## Appendix 1: Comparisons and photographs

### Larger windows and change to stairwell windows to the northern elevation:

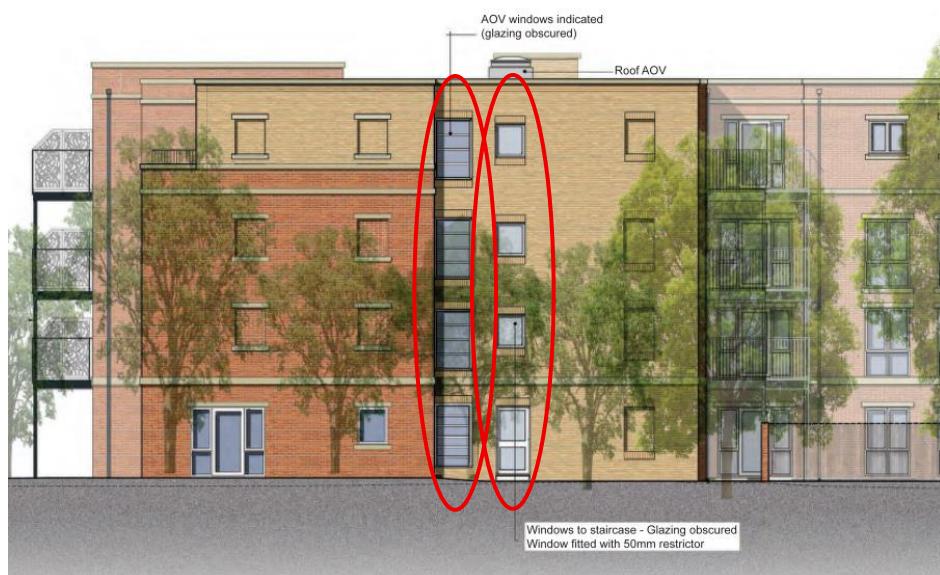
As approved:

Proposed:

**Plans updated to ensure consistency between floor plans and elevations plus safety railing added to eastern elevation**

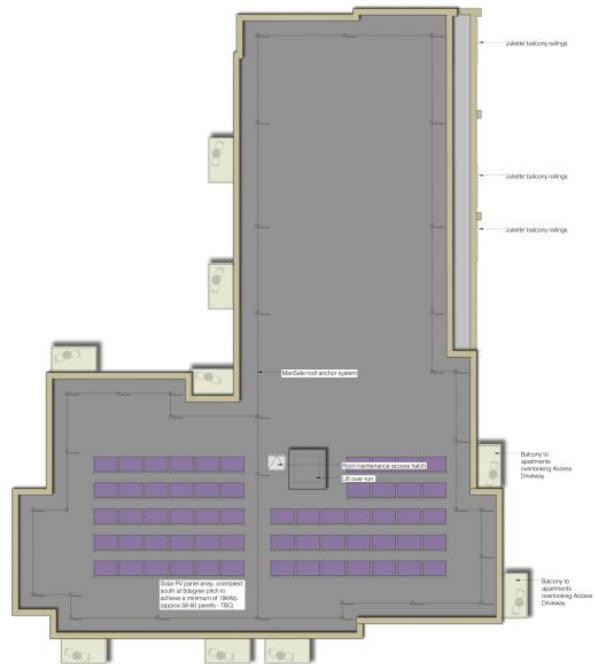
As approved:

Proposed:

## Addition of roof hatches:

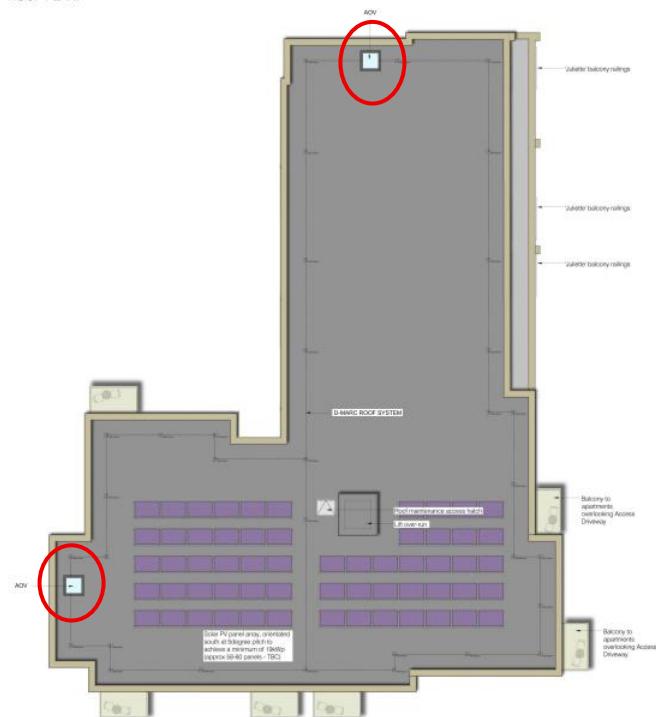
As approved:

Proposed:

**Omission of external stack balconies to western elevation and corner elevations:**

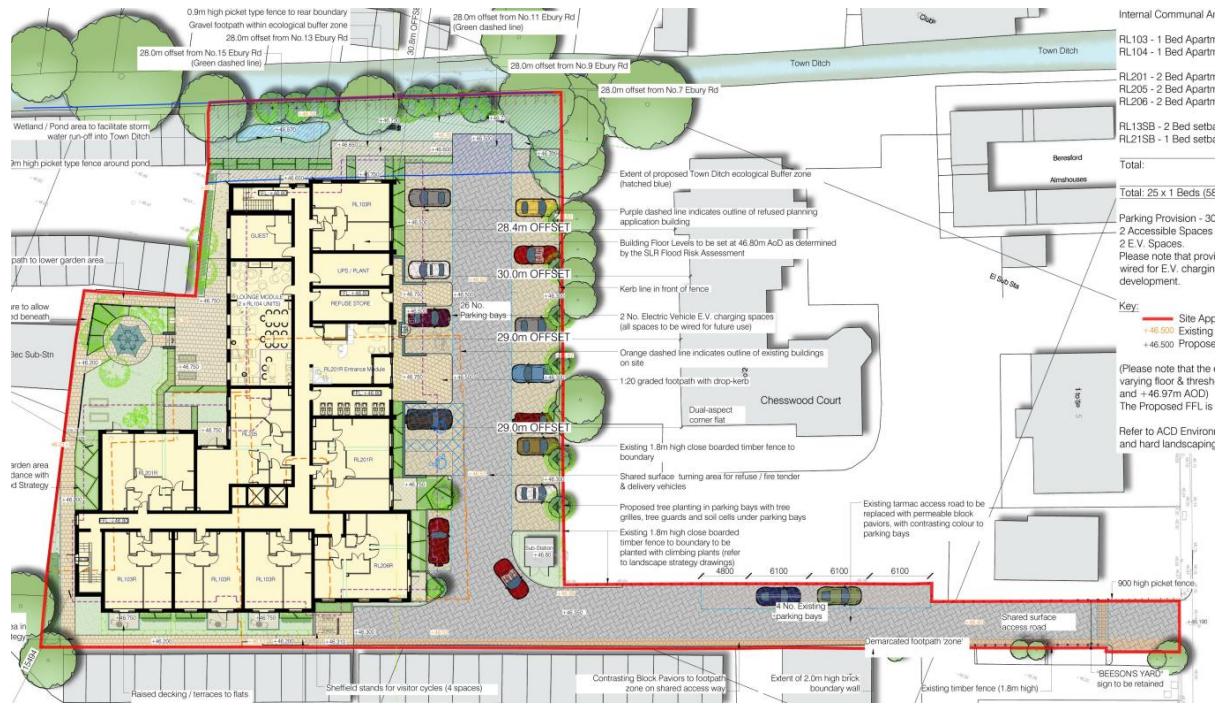
As approved:

**Proposed:**

## Site Layouts:

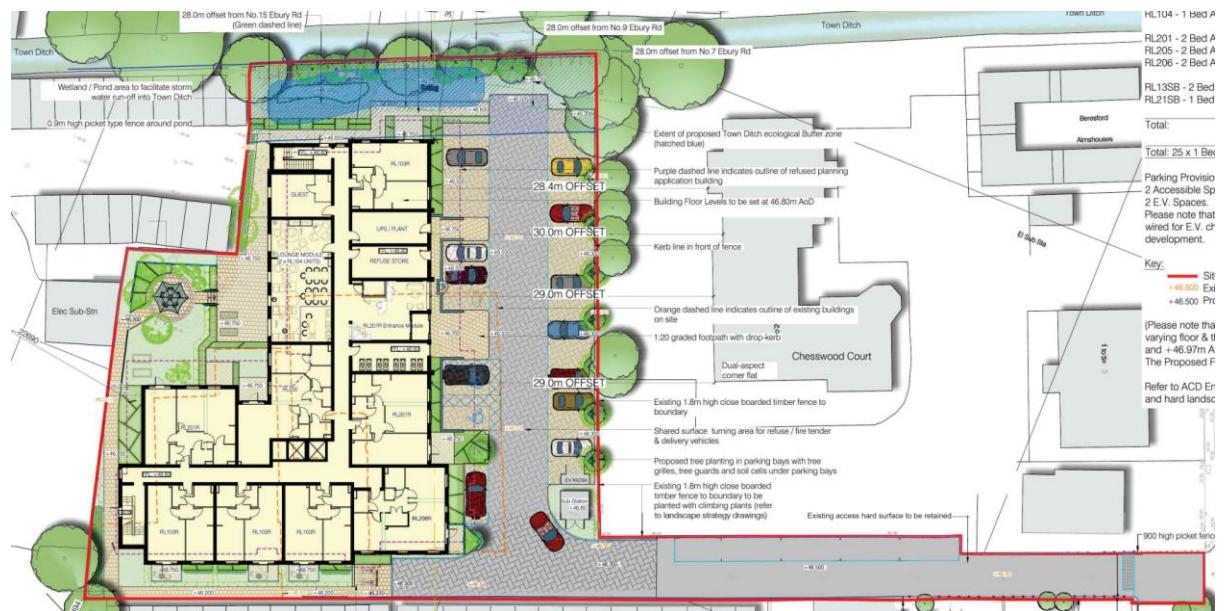
As approved:

### Proposed:
